Access Compliance Report

Public Rights-of-Way

(Curb Ramps)

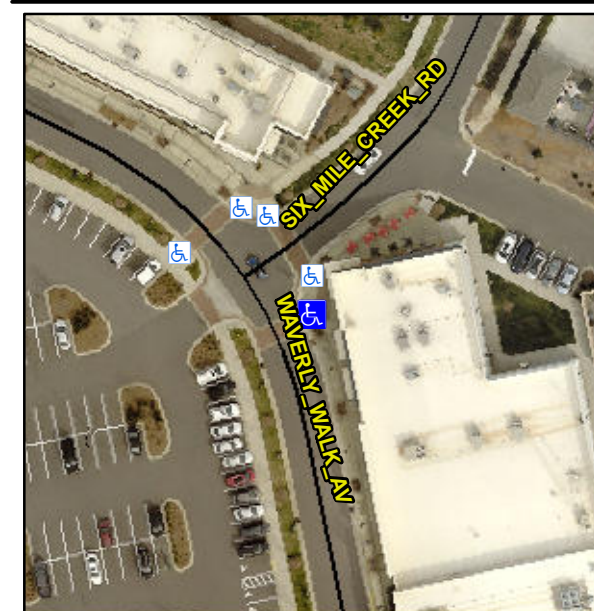
Intersection ID: N/A	Main Street: WAVERLY_WALK_AV	Cross Street: SIX_MILE_CREEK_RD	Location: SE
ADA ID: 1B6F65685A22	Ramp Type: Perp	Initial Pass/Fail: Fail	Overall Compliance: No
Severity Score: 8.75			
Codes/Mitigation Info/Possible Solution		Field Measurements/Component Compliance

Not Found, R304.5.1

Remove & Replace Entire Ramp.
